ST. TAMMANY PARISH

Addendum No.: 1

Bid#: 19-43-2

Project Name: Riverwood Subdivision and Covington Country Club Estates Drainage Improvements - Phase 2

SUMMARY OF ESTIMATED QUANTITIES

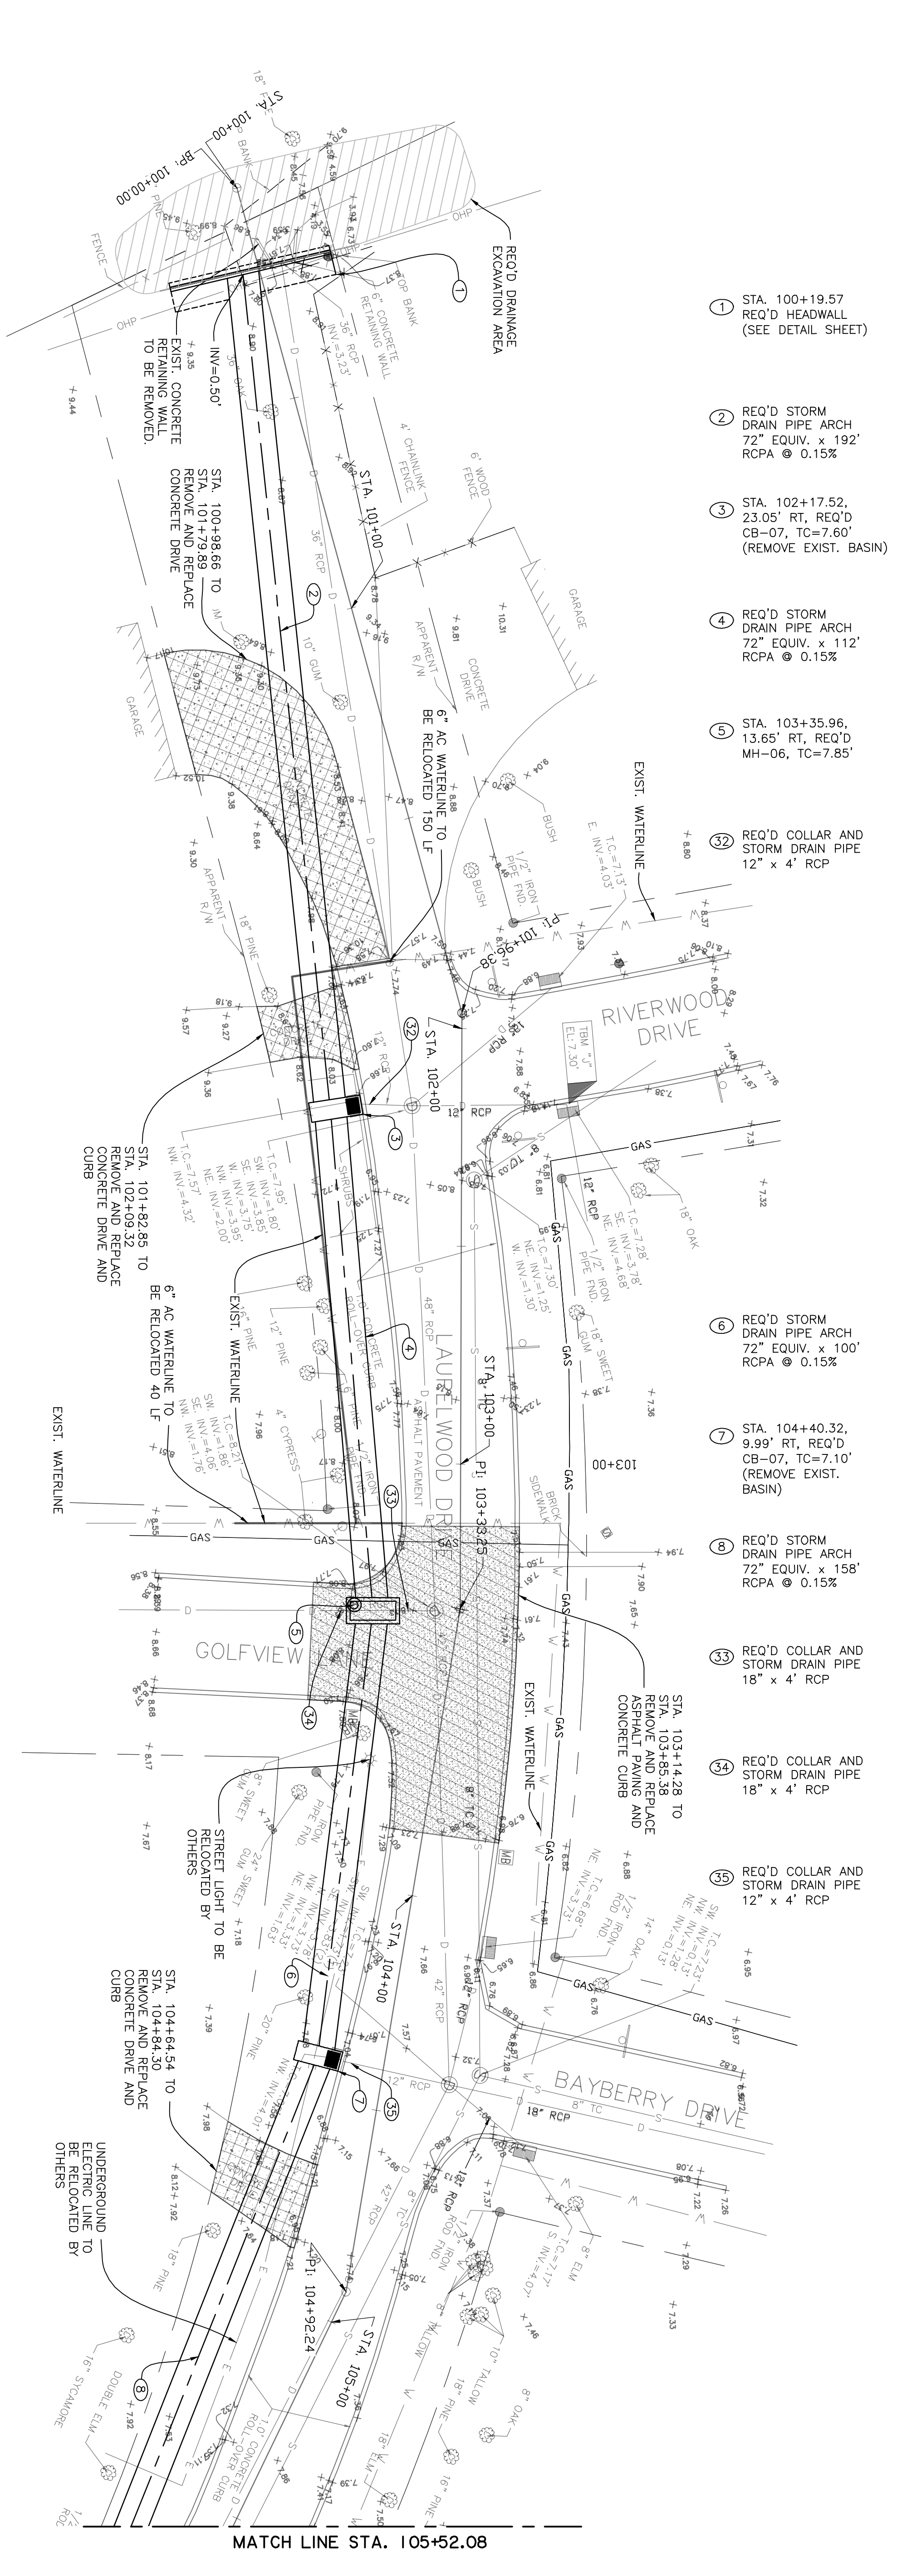
Question #10: What is the required bedding thickness for drain lines?

Answer #10: The required bedding thickness has been added to the Summary of Estimated Quantities plan sheet.

BEDDING THICKNESS IS 18" (MIN.)

NO.	DATE	REVISION DESCRIPTION	BY
I	12/19/19	REVISED QUANTITIES AND ADDED BEDDING THICKNESS NOTE

DESIGN CONSULTANT		RIVERWOOD SUBDIVISION AND COVINGTON COUNTRY CLUB ESTATES DRAINAGE IMPROVEMENTS - PHASE 2		12/19/19	REVISED F.L. ELEVATION OF STRUCTURE NUMBER 3	DESIGNED CHECKED	D.N.H. T.M.S.	PARISH	ST. TAMMANY	SHEET NUMBER	4
						DATE SHEET	11.SEP.19	FEDERAL PROJECT		STATE PROJECT	H.011458

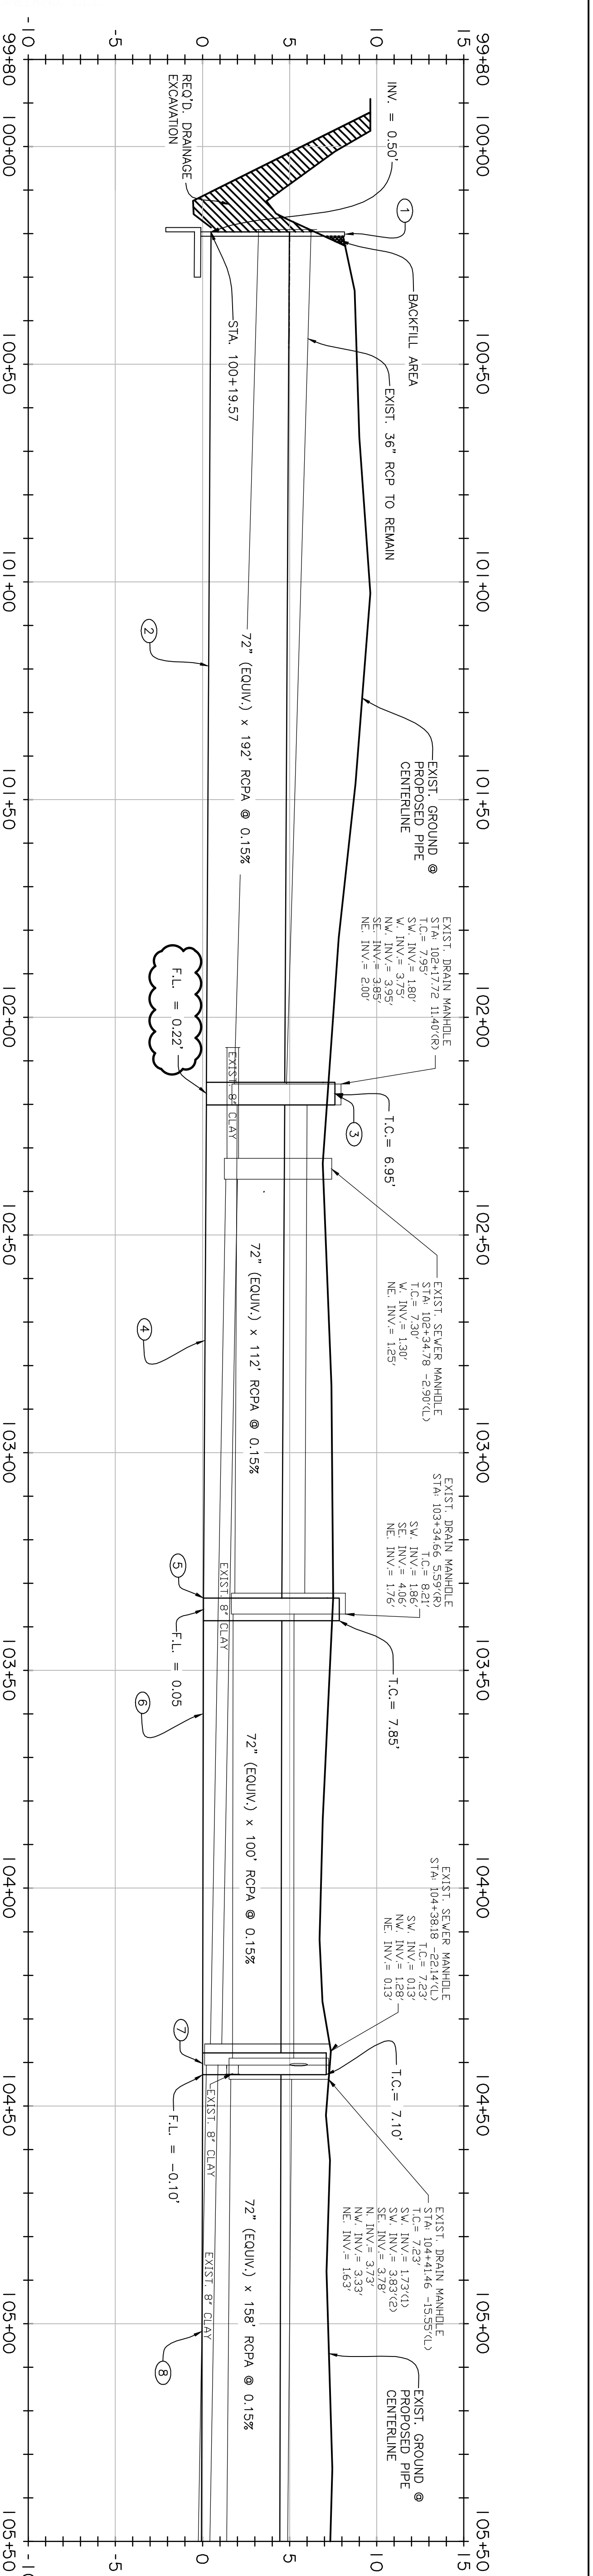
Question #8: The 150 LF section of waterline on sheet number 4, is that relocated line supposed to stay in the drain trench?

Question #13: The required CB-07 at Sta. 102+17.52 has an invert elevation of 3.60. This does not match the flow line of the system. Is this correct?

Answer #8: Yes, the relocated water line can be placed in the same trench as the drain line.

Answer #13: No, that label is in error. Plan sheet 4 has been revised to correct the invert.
